U.S. Nuclear Regulatory Commission Operations Center Event Report

PART 21 - LOOSE BATTERY VENT ASSEMBLIES

Subject: Preliminary Notification – Krsko Vent Fitment

Ref: Possible Problem with LCY Vent Assembly Fit

Figure 1

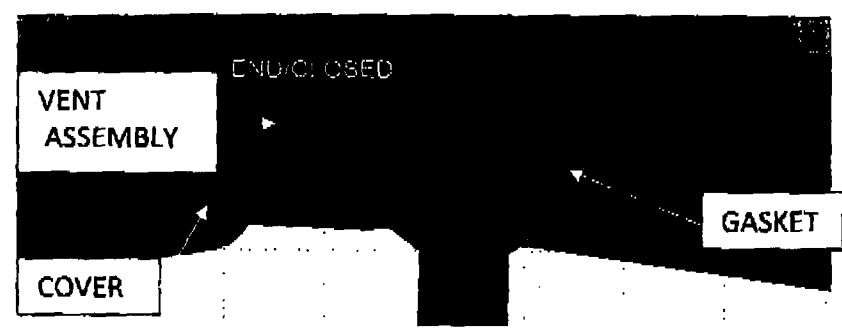
**Vent Assembly Installation:** The vent assembly has a bayonet fitting. It is inserted into the vent hole on the cover, and twisted to form a seal against the cover. A gasket is used to seal the interface between the cover and vent assembly, preventing sparks or flames from entering the cell. (See Figure 1 for cross section of the assembled seal).

In the case of the NEK batteries the vents were installed, however, there was no resistance when the vent assembly was turned. This indicated that the gasket was not being compressed, and

that there may be a clearance fit that could provide a path for sparks or flames if the vent was disturbed (i.e., during seismic events, etc). A subsequent fit analysis of the LCY cover revealed that there were combinations of gasket, cover, and vent assembly dimensions that may allow clearance fits of up to 0.006", even when all parts were in tolerance. Similar analysis of all other safety related product lines (LCR, LCUN, KCR, 4LCY, DCU) showed that positive seals were present under all combinations of tolerances.

If freely turning assemblies are found, or if the user has any doubt that a seal is being formed C&D will provide thicker replacement gaskets. The user should contact C&D at the numbers below for additional information.
